**project.** Sherwood Library Renovation | 1225 Wonderland Rd N, London, ON

**project no.** 23-006

This Addendum is issued before the award of Contract to inform the Contractor of certain modifications to the work described in the Drawings and Specifications dated September 18, 2024.

end of addendum | 001

A230 Scale: 1" = 1'-0"

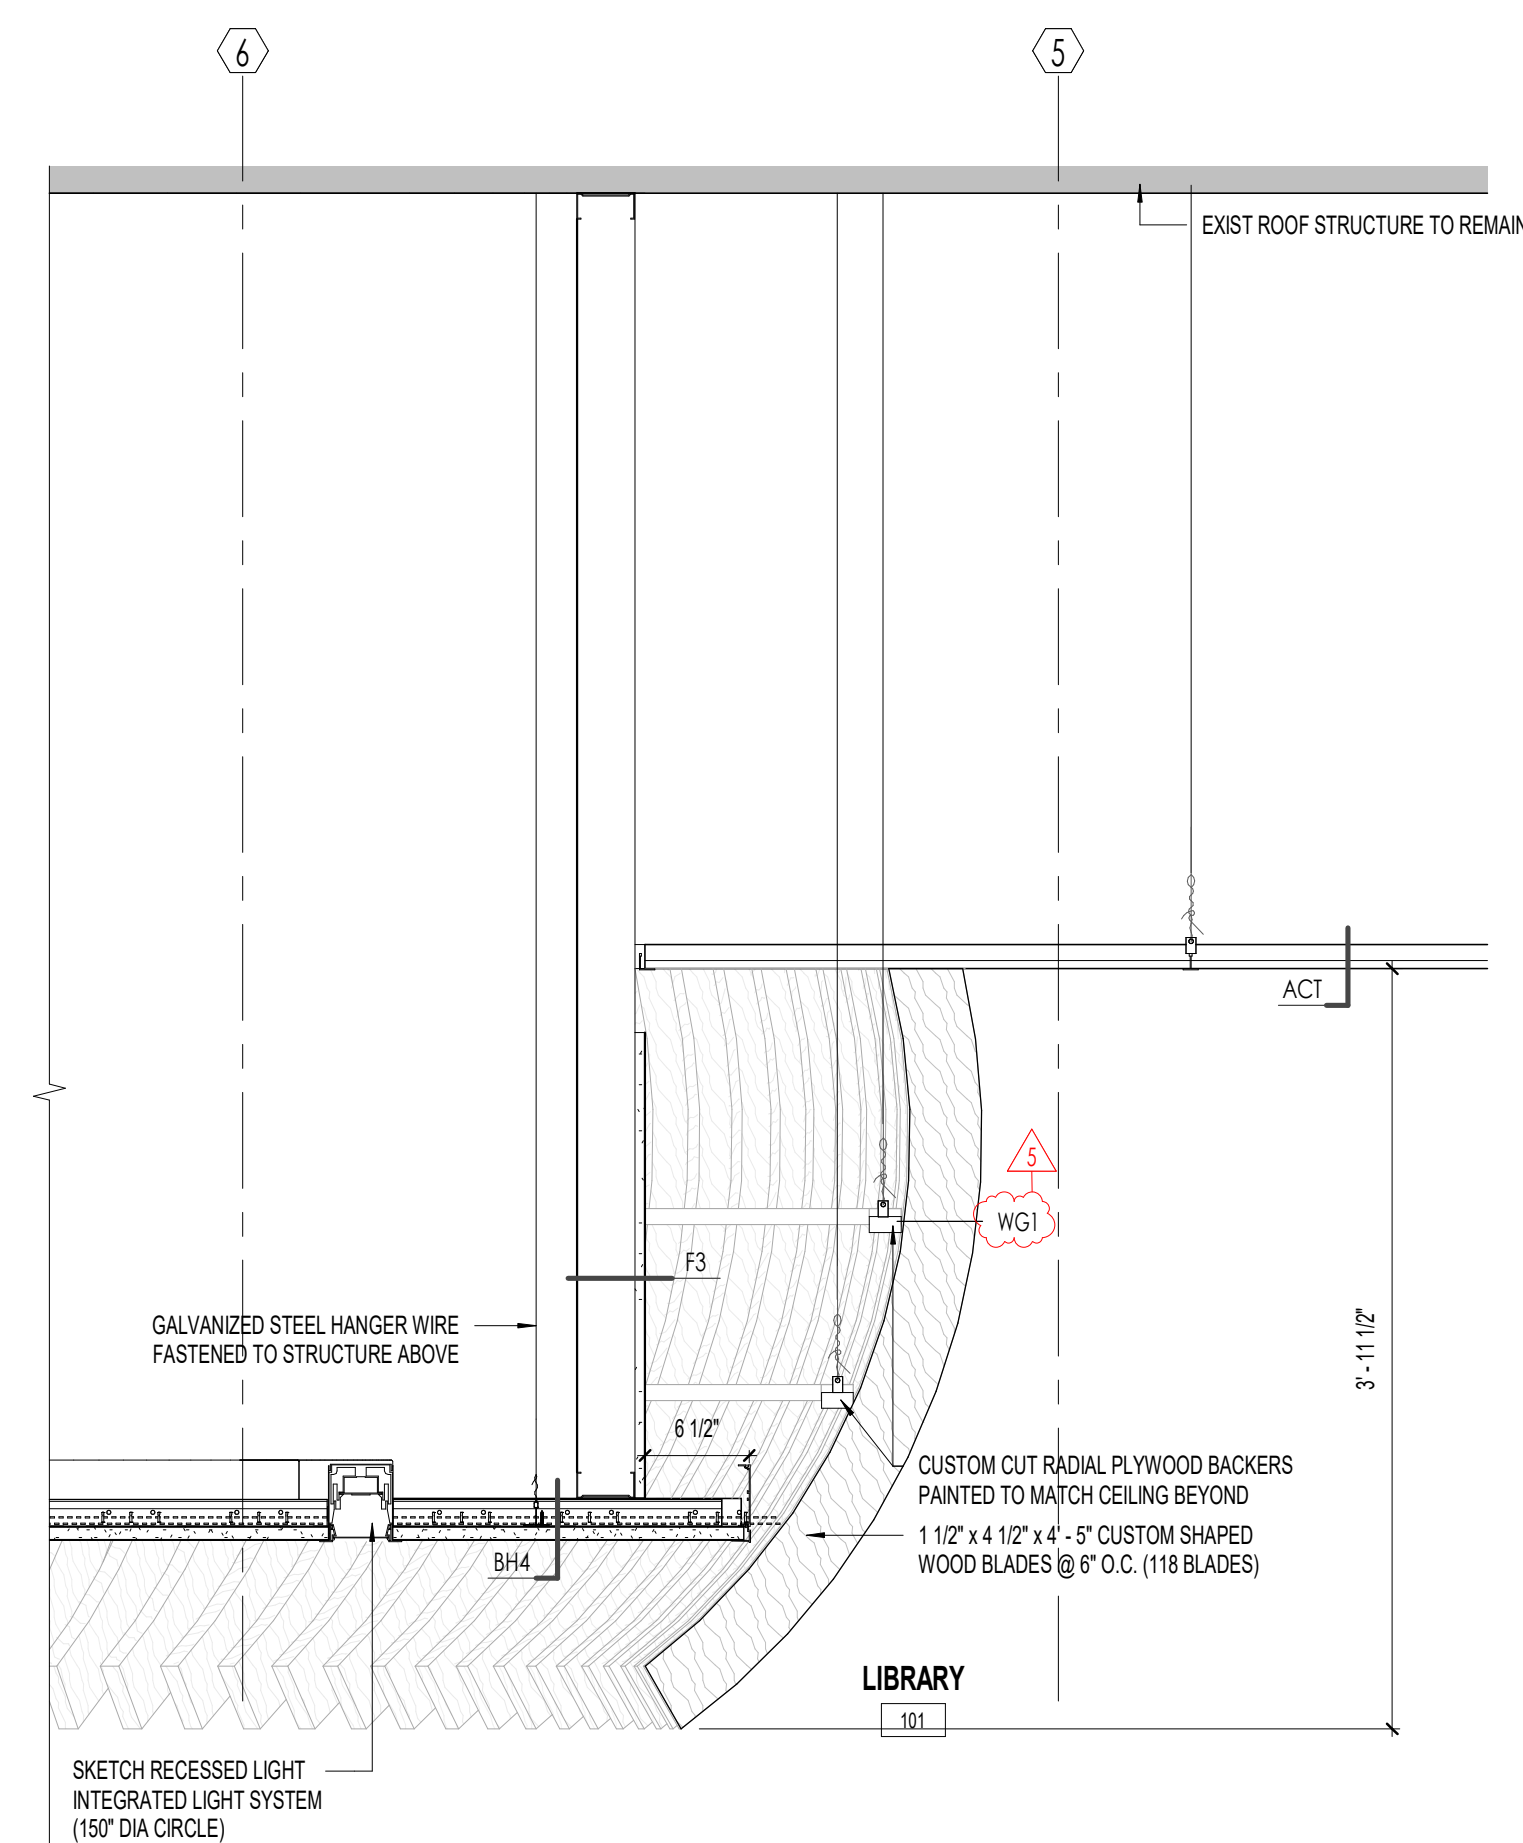
item no.	REFER TO DESCRIPTION
1	<b>Contractor/Sub-Trade Questions (Received by 2024.10.02)</b>
<b>CEILING QUESTIONS:</b>	
1.1	<p><b>Question:</b> A230 Ceiling Design- Will there be a product spec or preferred vendor for purchase?</p> <p><b>RESPONSE:</b> The ceilings on architectural sheet A230 are an Armstrong product composed of AcoustiBuilt suspended ceiling systems (BH4) and Wood Grille Backer ceiling system (WG1). Please see attached Specifications for these ceiling systems. Updated sheet A320 has been included for clarification on the verbiage pertaining to these systems.</p>

<b>3</b>	<b>Architectural Drawings (Addendum 001) dated 2024.10.02 (4 pages)   have regard to revisions and/or clarification to the following drawings</b>
3.1	<p>A-230 CEILING DETAILS</p> <p>Refer to attached revised A320.</p> <p><b>Revise verbiage for WG1 system, including wood grille panels.</b></p>
3.2	<p>ICC-200 MILLWORK KEY PLAN - NORTH</p> <p>Refer to attached revised ICC-200.</p> <p><b>Revise MILLWORK FINISH LEGEND and remove:</b></p> <ul style="list-style-type: none"> <li>• <b>Plam 3, Plam 4, Plam 5</b></li> <li>• <b>UP1, UP2, UP3, UP4, UP5, UP6</b></li> </ul>
3.3	ICC-200 MILLWORK KEY PLAN - SOUTH

Project No:  
 23-006  
 Sheet No:  
 ICC-200

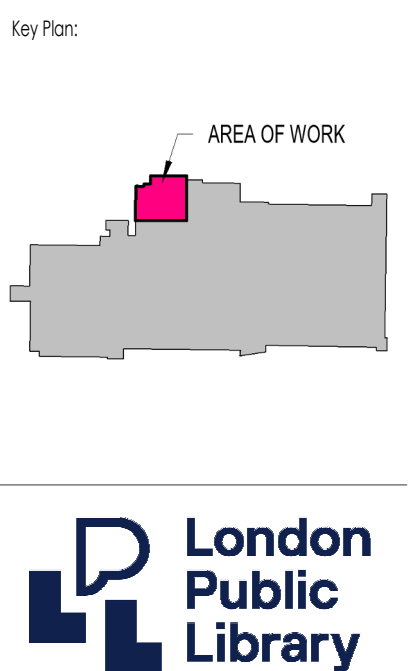
1.4 **Upholstery Question:** On ICC Drawings ICC-200 and ICC-201 it is mentioning Upholstery for "The Nest" but there isn't anything noted on the drawings as to where this is. Can you confirm it's location?

**RESPONSE:** There is no upholstery, all furniture is N.I.C. MILLWORK FINISH LENGED on ICC-200 and ICC-201 is revised as follows:

MILLWORK FINISH LEGEND		
MILLWORK FINISHES		
SS1	SOLID SURFACE: MILLWORK (OR APPROVED EQUAL) SOLID QUARTZITE (SQA)	
PLM1	LAMINATE: FORMICA (OR APPROVED EQUAL) SHIMMER WPT (SW) - (SOLID WOOD FINISH (WPT))	
PLM2	LAMINATE: FORMICA (OR APPROVED EQUAL) RECYCLED BLACK

Project No:  
 23-006  
 Sheet No:  
 ICC-201

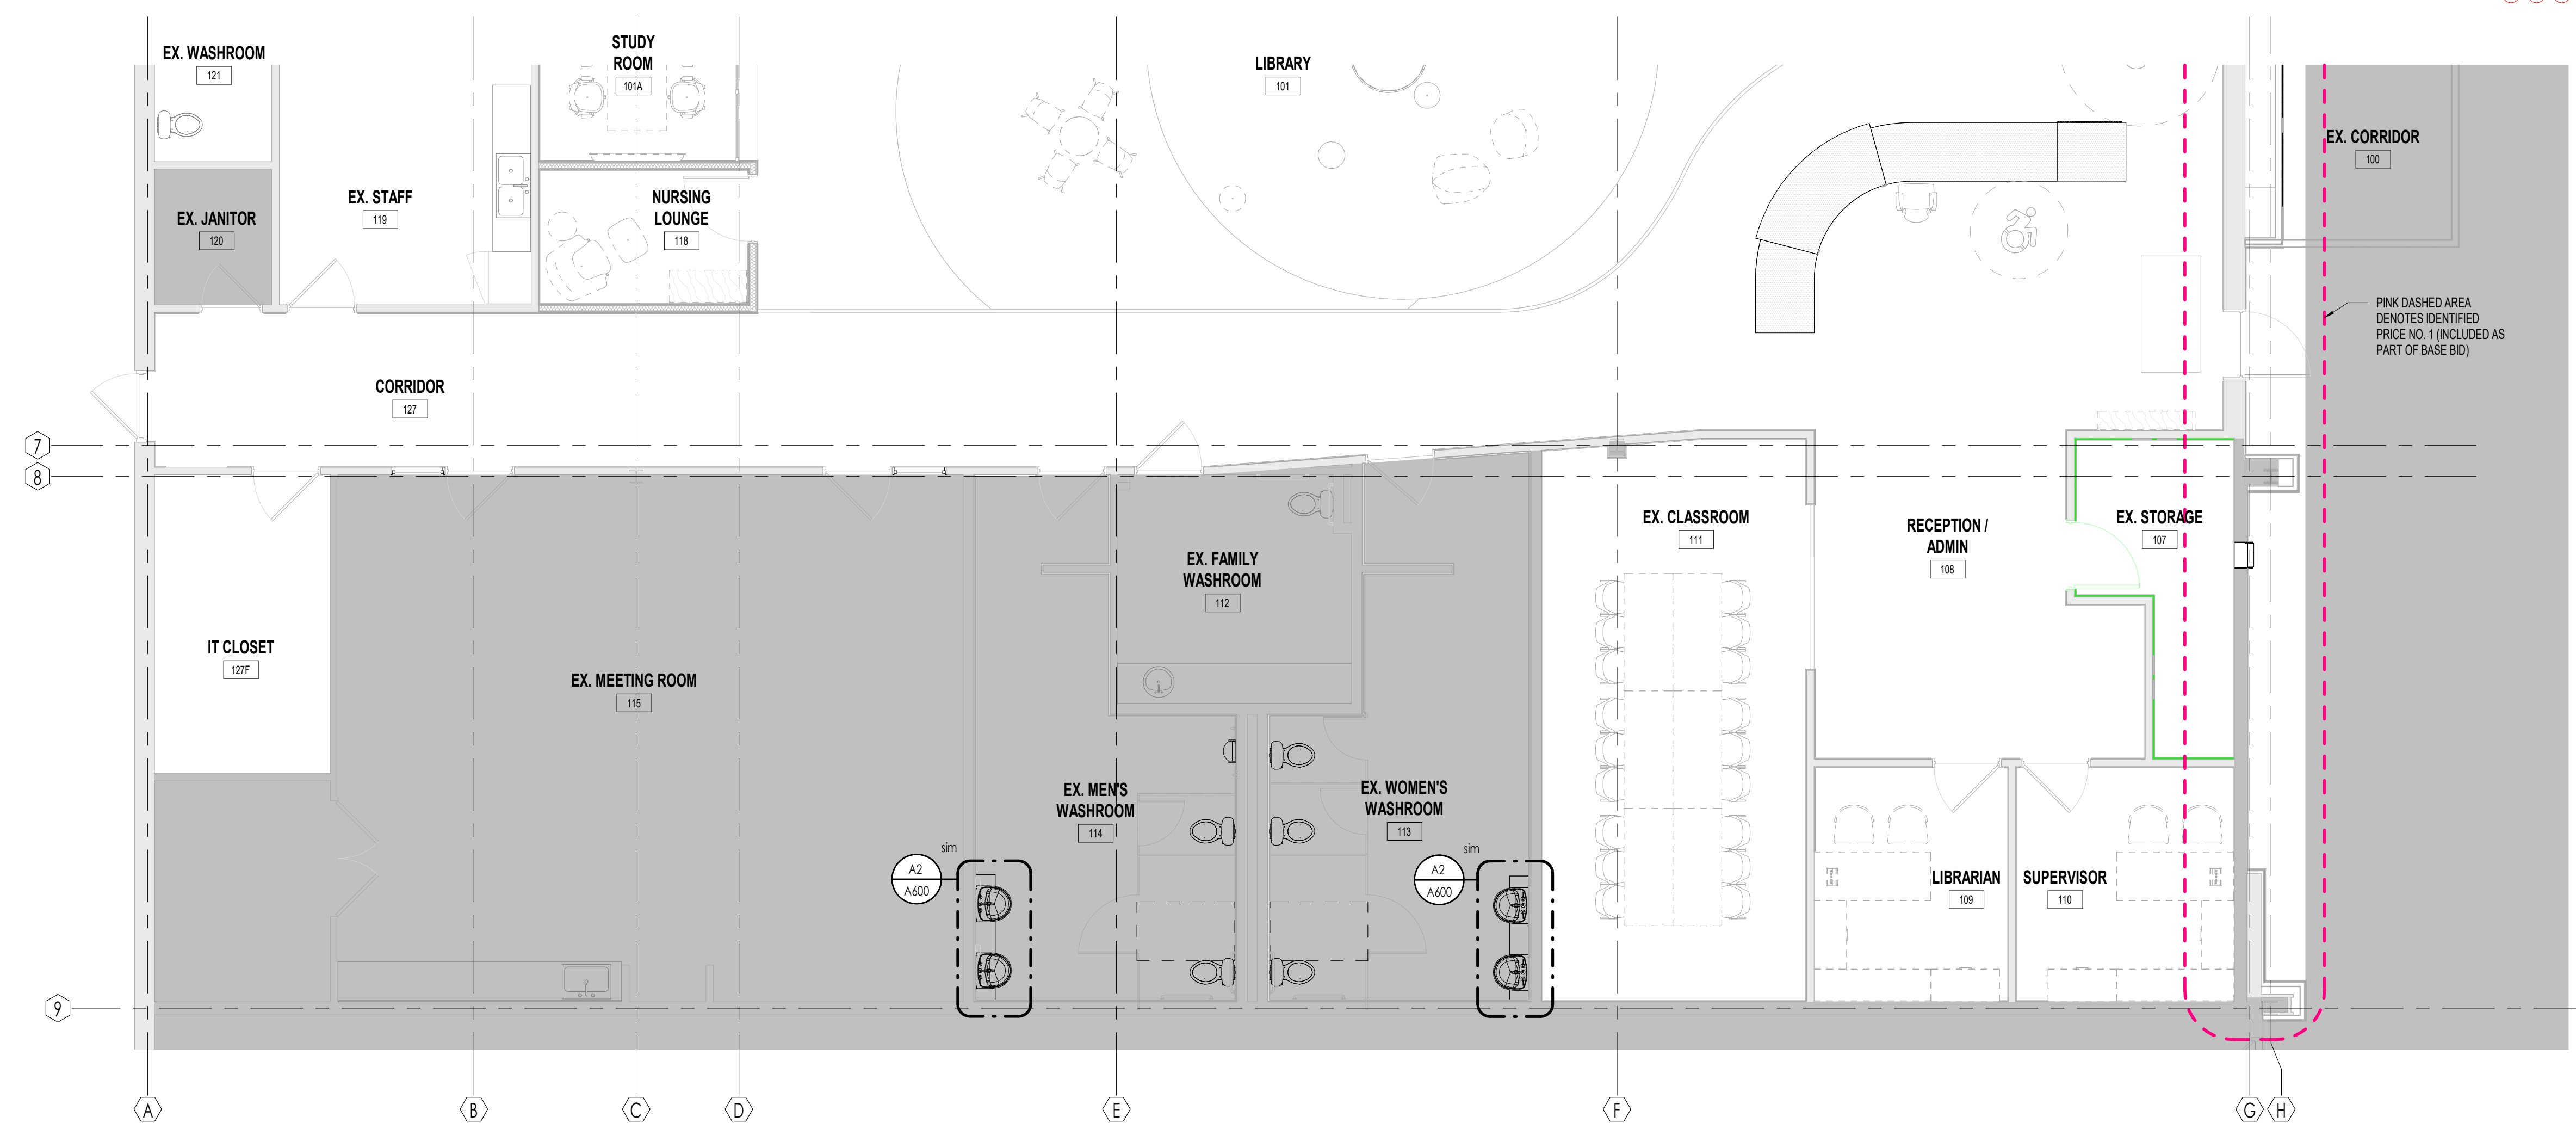
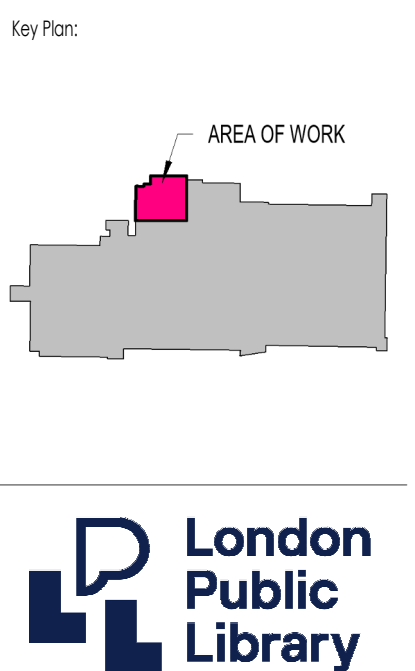
Refer to attached revised ICC-201.  
**Revise MILLWORK FINISH LEGEND and remove:**

- **Plam 3, Plam 4, Plam 5**

**UP1, UP2, UP3, UP4, UP5, UP6**
